**Appl. No.** : **10/647,369**  
**Filed** : **August 25, 2003**

**COMMENTS**

ENGINE COUPLING SYSTEM  
Masanobu Yamamoto  
Appl. No.: Unknown Atty Docket: FY.50687US0A

**FIG. 2**

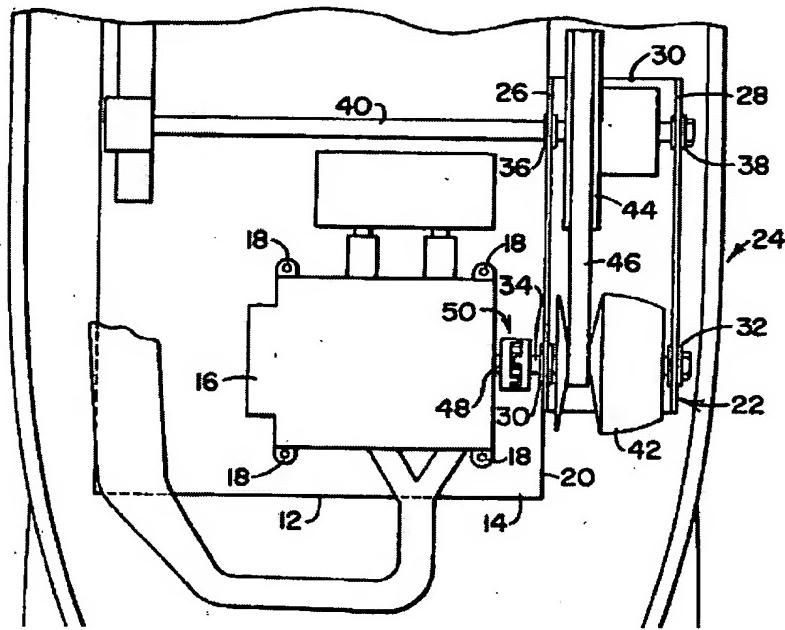
Leonard et al. '882 teaches a snowmobile having an internal combustion engine 16 mounted in a conventional manner. As shown in the enlarged portion of Figure 2 reproduced below, the crankshaft 48 of the engine 16 extends outwardly from the engine body to a coupling device 50 which is disposed on the *outside* of the engine 16.

A coupling 50 is also disposed on the outside of the engine 16. The coupling 50 connects the end of the crankshaft 48 with another shaft 34. The shaft 34 is supported by bearings 30 which are also disposed on the outside of the engine 30. In particular, the bearings 30 are supported by a wall 20 which forms a portion of the frame 12 of the snowmobile. Thus, it is crystal clear that the shaft 34 is *completely outside* of the engine 16 and is in fact supported by the bearing 30 mounted *on the frame* of the snowmobile and by the coupling 50 which is also disposed *completely outside* of the engine 16.

Nowhere does Leonard et al. ‘882 teach or suggest such an arrangement of a coupling system being mounted in a crankcase of an engine. Rather, as shown in Figure 2 of Leonard et al. ‘882, as noted above, the driven shaft 34 of Leonard et al. ‘882 is supported by bearing 30 that is mounted to a sidewall 20 of the frame 12 of the snowmobile. Thus, applicant submits that Claims 1 and 10 clearly and non-obviously define over the Leonard et al. ‘882 reference.

FIGURE 1

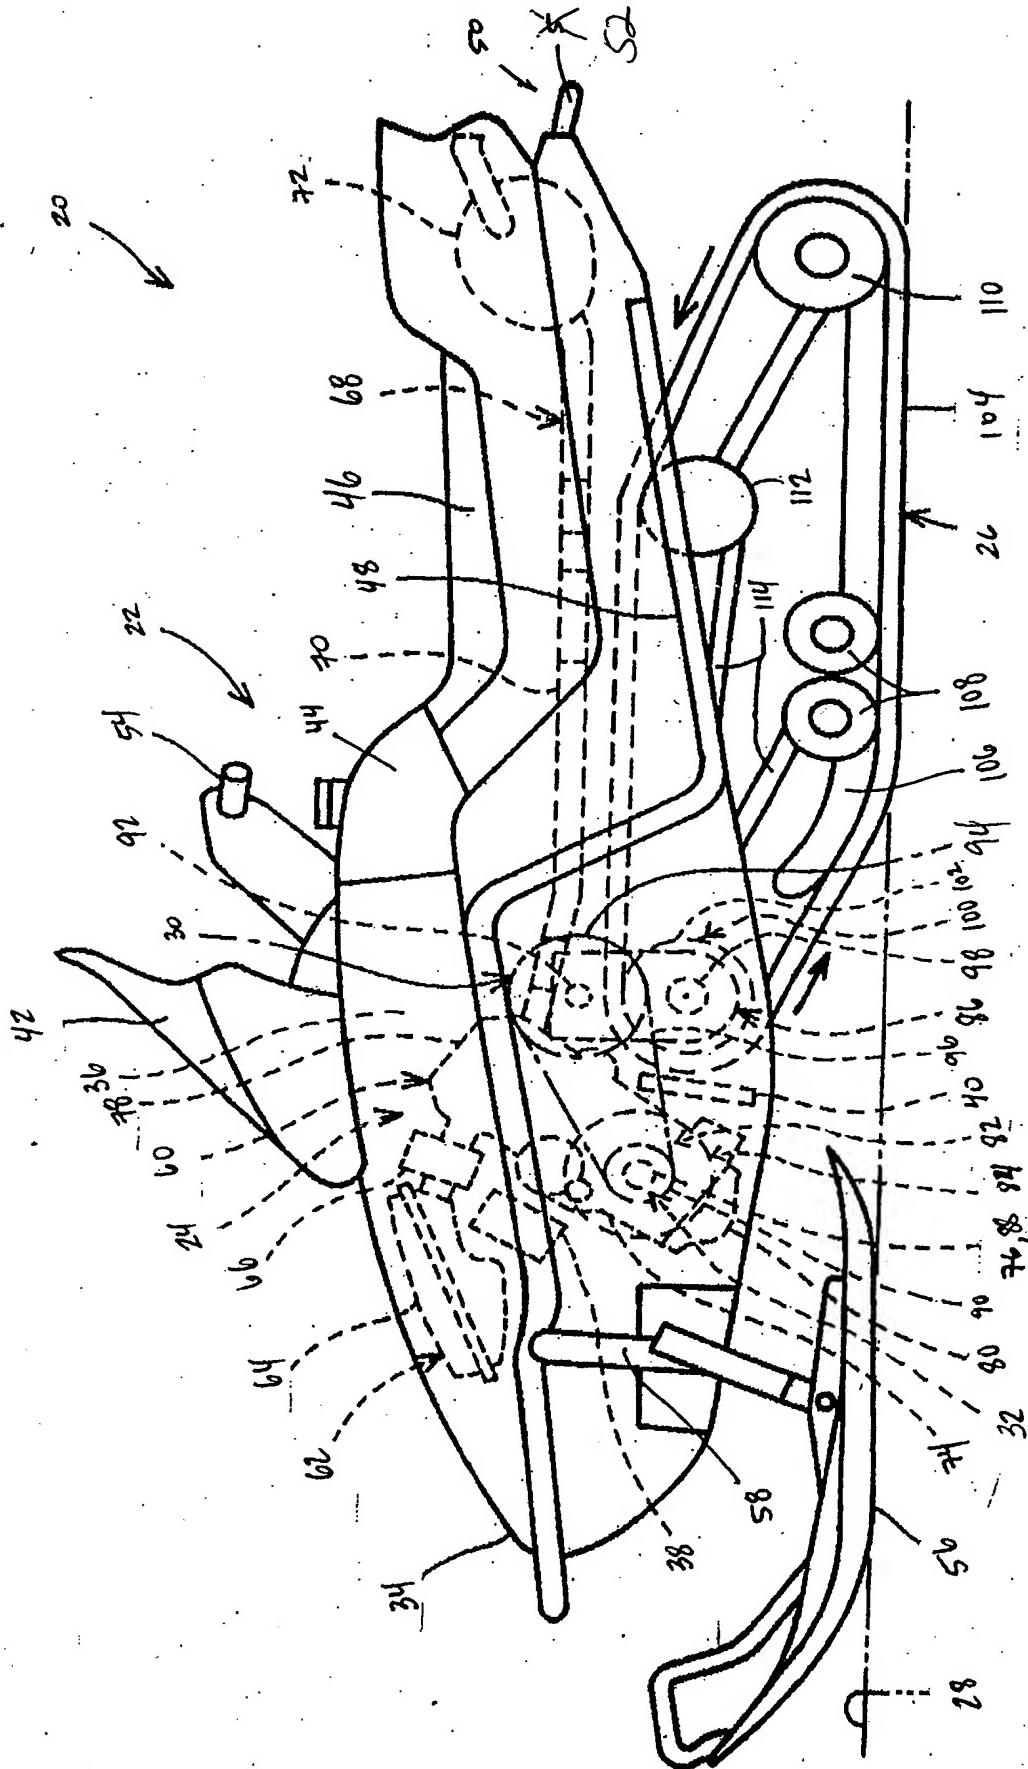
In Figure 1, please change reference numeral "5" to "52".

The drawings stand objected to under 37 CFR § 1.84(p)(5) based on certain informalities. In response, Applicant has amended Figure 1 to change the reference numeral "5" to "52". Additionally, in Figure 3, Applicant has deleted the secondary use of reference characters "62, 64" and the lead line extending therefrom. Applicant has included herewith a marked up set of Figures 1 and 3 showing the changes noted above as well as replacement sheets including amended Figures 1 and 3.
